World Forum for Harmonization of Vehicle Regulations

Working Party on Lighting and Light-Signalling

Proposal for Supplement 18 to Regulation No. 4 (Rear registration plate lamps)

Submitted by the experts from Japan and Finland*

(a) **Category 1a**

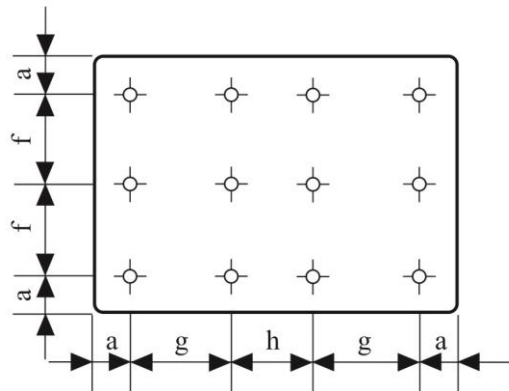
~~devices for illuminating a tall plate (340 x 240 mm)~~

(c) **Category 1c**

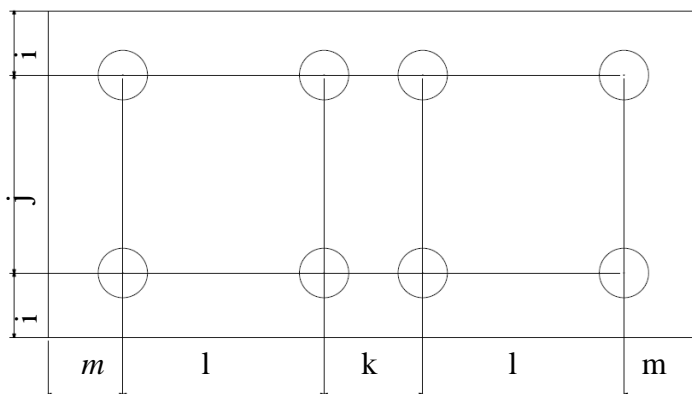
~~devices for illuminating a plate for agricultural or forestry tractors (255 x 165 mm)~~

| a = 25 mm | b = 95 mm | c = 100 mm | d = 90 mm |
| e = 70 mm | f = 57.5 mm | g = 65 70 mm | h = 60 65 mm |

Category 2a (330 x 165 mm)

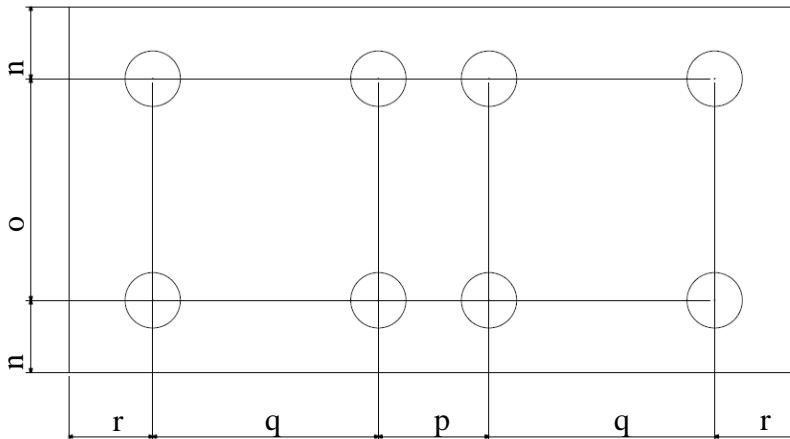
- i = 32.5mm**
- j = 100mm**
- k = 50mm**
- l = 100mm**
- m = 40mm**
